**BEFORE THE HON'BLE NATIONAL GREEN TRIBUNAL
SOUTHERN ZONE, CHENNAI**

ORIGINAL APPLICATION NO.104 OF 2020

REPORT OF JOINT COMMITTEE IN THE MATTER OF O.A. 104 OF 2020 (M/s. MOTHER EARTH ENVIRON TECH PVT LTD.) SUBMITTED BEFORE THE HON'BLE NATIONAL GREEN TRIBUNAL, SOUTHERN ZONE, CHENNAI

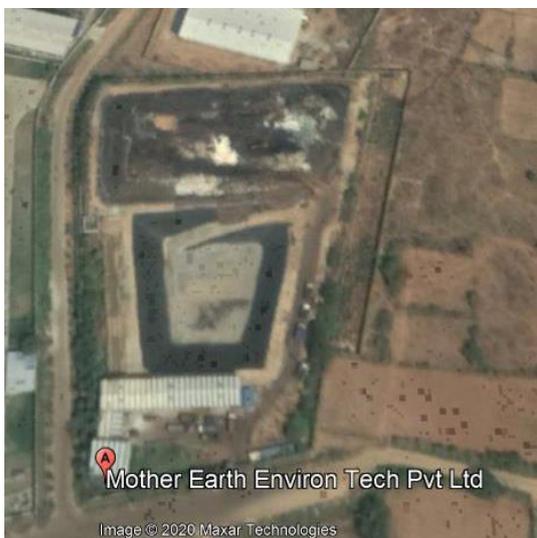
Cell 1 landfilling was in progress As on 18.12.2017 and Cell 2 development in progress

Cell 1 landfilling was in progress as on 05.01.2018 and Cell 2 development in progress
